**PAP/2018/0140**

**Land East of Castle Road and North of Camp Hill Road, Hartshill and Nuneaton**

**HARTSHILL QUARRY - POTENTIAL IMPACTS ON  
BLASTING PRACTICES OF A PROPOSED HOUSING  
DEVELOPMENT**

**Report Title:** Hartshill Quarry - Potential Impacts on Blasting Practices of a Proposed Housing Development

**Table 3 – Example adjusted blast designs to meet vibration constraints due to proposed development**

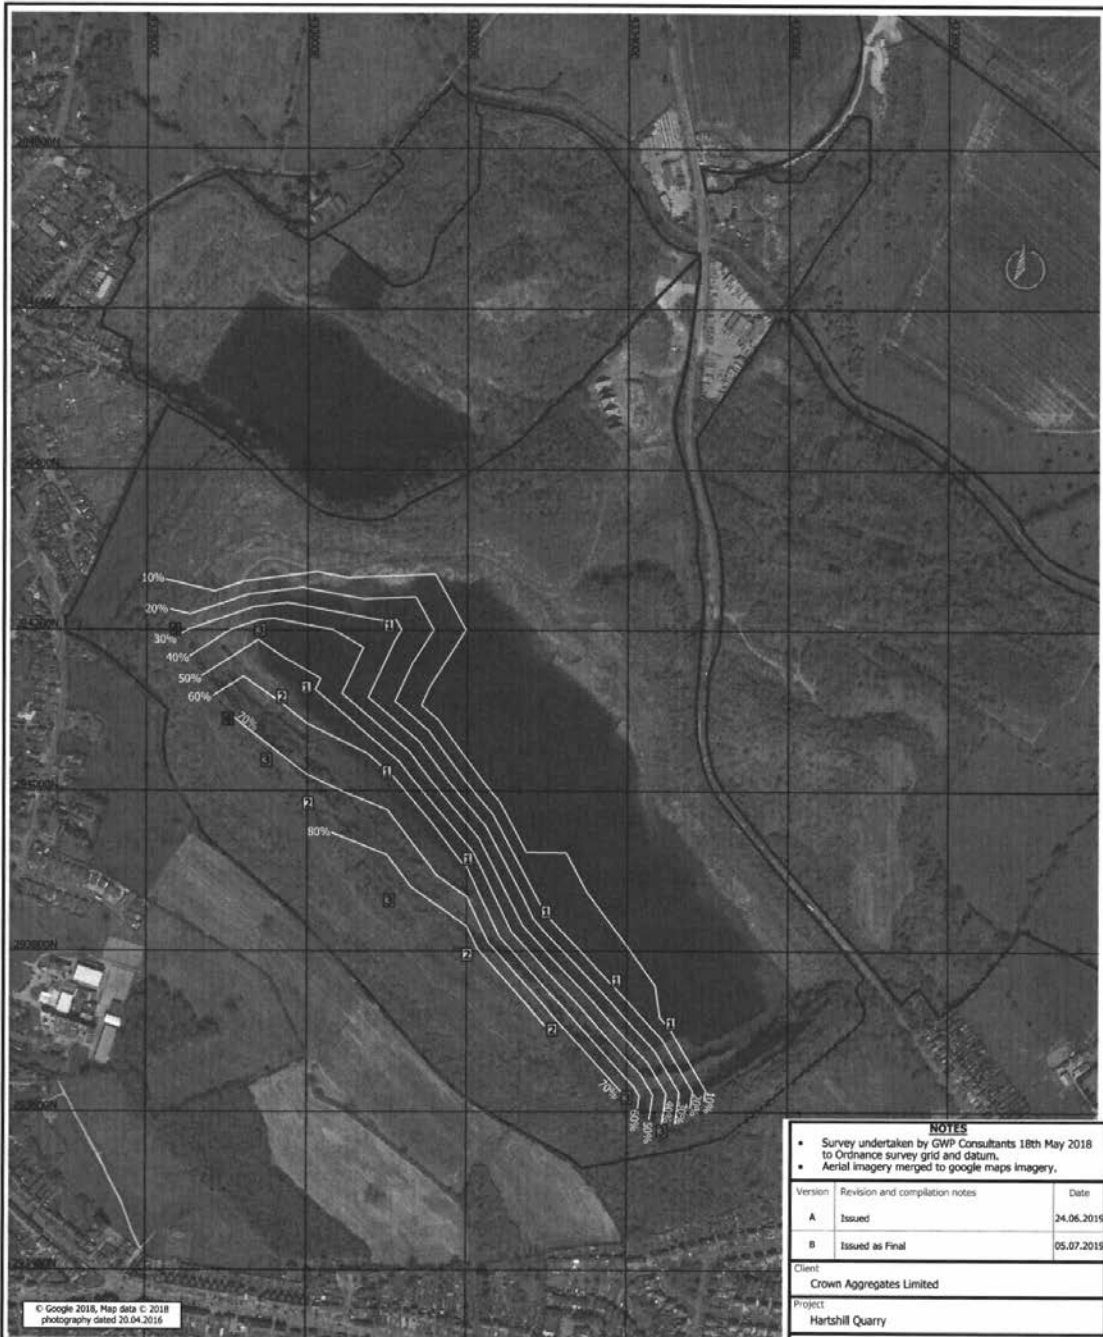
By constructing a large number of houses a short distance behind the south western quarry rim, the proposed development will significantly reduce the distance between production blasting along the south-western slopes of the quarry and sensitive receptors. To ensure that PPV at these new receptors does not exceed 6mm/s and to minimise the air overpressure, the MIC per delay would need to be reduced for a large proportion of the remaining mineral resource compared to what would be necessary without the new houses.

Post-development MICs are compared with the maximum allowable MIC (based on the scaled distance relationship) in Drawing No. HARTSHIL1906-1. Reductions in MIC of up to 80% would be required along the south-western faces. Total reductions in MIC would range between 10 and 180kg depending on proximity to the south-western boundary.

Compared with the reference blast design (MIC 39.5kg) post-development reductions in MIC are lower, at between 35% and 75%. The area requiring deviation from the reference blast design would extend between 40-100m from the limit of excavation. Depending on the scale of the MIC reduction compared to the reference blast, adjustments will be required to blast designs as described in the above table.

Where post-development reduced MICs match or exceed the reference blast design (MIC 39.5kg) it has been assumed that no adjustment would be required to blasting practices. Adjustments to the reference blast design due to the constraints of the proposed development fall into four general categories:

The approximate areas of each blast design adjustment category, based on the reference design, are illustrated on Drawing No. HARTSHIL1906-1.

Category 1 areas, requiring no adjustments to the reference blast design, will generally be greater than 170m (MIC ~39.5kg) from the boundary of the proposed development. Adjustments to the reference blast design will generally be required within 170m of the proposed development boundary (also dependant on existing constraints).
